Application for Waiver from Construction Standards for Public Water Systems

Water System Name Chehalem Valley Winery Tasting Room	PWS ID	<u>95731</u>
Project or Facility 5,300 Potable Water Tank	County	Yamhill
Need for waiver identified: Water System Survey Plan Review # 28-2024	Date of Survey	N/A
Construction standard requested to be waived: OAR 333-061-	0050 (6)(a)(K)	
(K) Internal ladders of durable material, shall be provided	led where the only	v

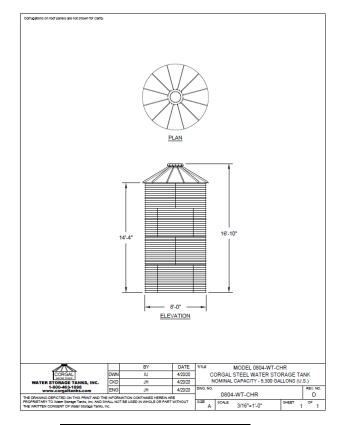
Describe situation that conflicts with the standard. The only access to the inside of the manufactured 5,300-gallon CorGal potable water storage tank (manufactured by Water Storage Tanks, Inc.) is on the roof. The tank has an exterior ladder, however, the tank does not have a permanently affixed internal ladder.

Describe why meeting the standard is highly burdensome or impractical. The manufactured tank is relatively small and has an internal liner system (as shown), which makes affixing an internal ladder difficult and may void the tank manufacturer's warranty as this is not a standard construction feature for this style of tank. The tank has an internal liner and a ladder is unable to attach to the walls without damaging the liner.

Describe proposed alternate measure that provide adequate protection to public health and safety. Entry to the tank will be treated as a confined space entry and a stepladder (with padded feet to protect the NSF-61 interior liner from damage) will be lowered into the tank when entry is needed per the

Waiver ID 520-2025 Entered into waiver database Plan Review Coordinator's notes: Proposed mitigation is an acceptable alternative. After due consideration the above requested waiver from the construction standards of OAR 333-061-0050 is hereby: Approved Comments: Reservoir hatch must remain locked to address safety issue. Comments: Reservoir hatch must remain locked to address safety issue. Denied 2/20/2025 Drinking Water Regional Manager Signature Date
